ID No. TT-24-013  
Ref. No. HMM-241217-Y1  
Release Date 12-19-2024

### TT-24-013 22-25 MY RF BRAKE AIRLINE REROUTE

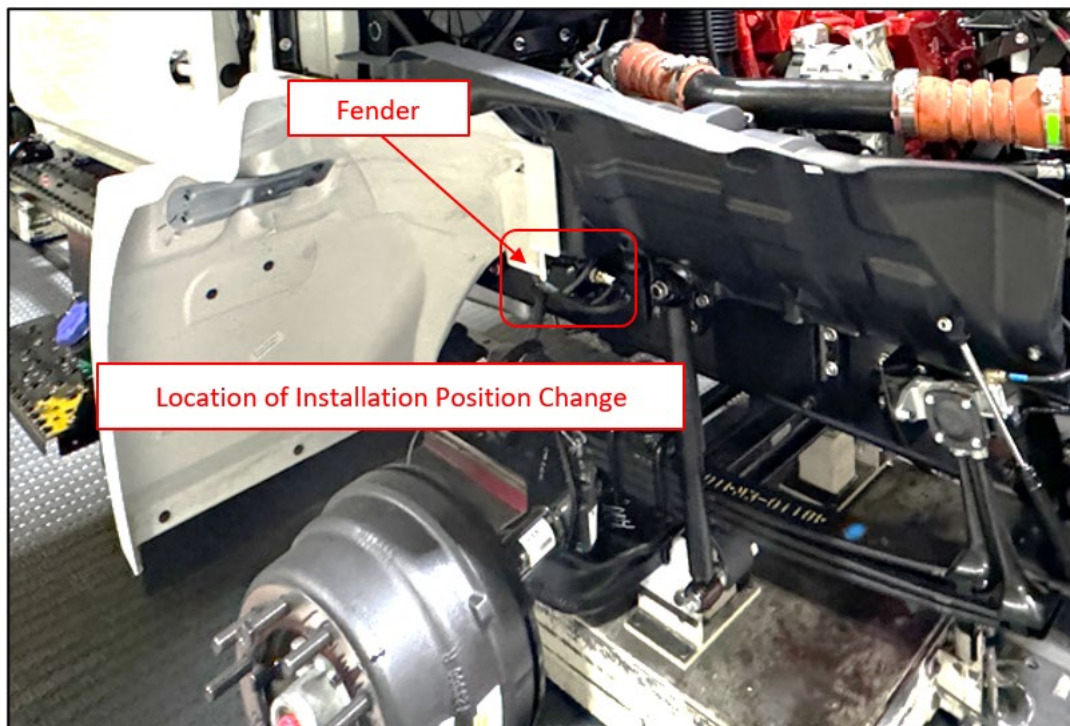
The installation position of the nylon brake line to the passenger front air brake modulator has been adjusted on vehicles produced after 7/31/2024. This change was made in response to field reports that found contact occurring between the lower edge of the fender and the nylon air brake line. If the nylon line is being replaced see below for the recommended installation position.
